***In the Drawings***

## **REMARKS**

FIG. 2

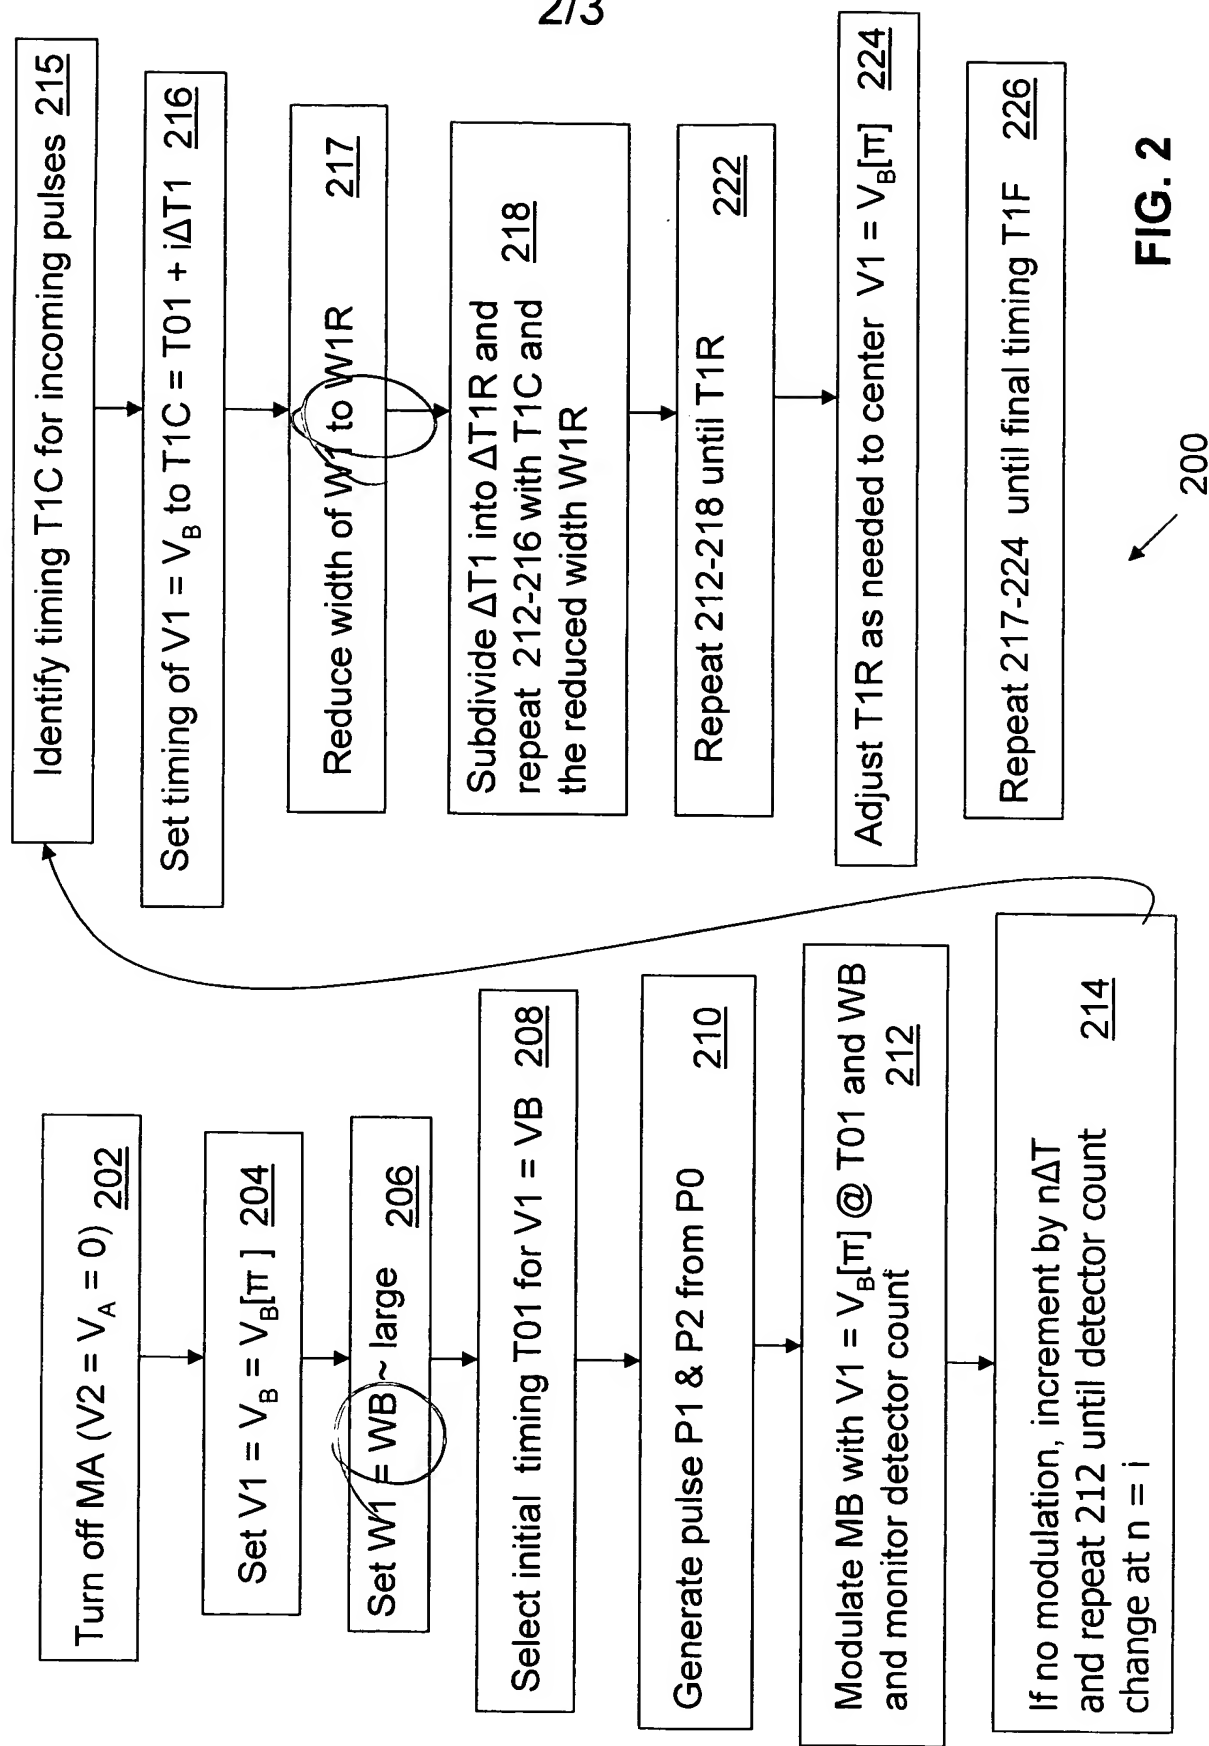
FIGS. 2 and 3 were amended to make certain sections of the flow diagram more consistent with the language of the specification, particularly as set forth on pages 7-11 for FIG. 2 and pages 11-13 for FIG. 3, in connection with activation signal widths W1 and W2 and the "coarse" values of  $W1 = W1C$  and  $W2 = W2C$ . Replacement sheets for FIGS. 2 and 3 are provided, along with annotated sheets indicating the changes in red.

Please replace FIGS. 2 and 3 with the amended FIGS. 2 and 3 per the attached replacement sheets for these Figures. Annotated sheets are provided that illustrate the amendments made to these Figures.
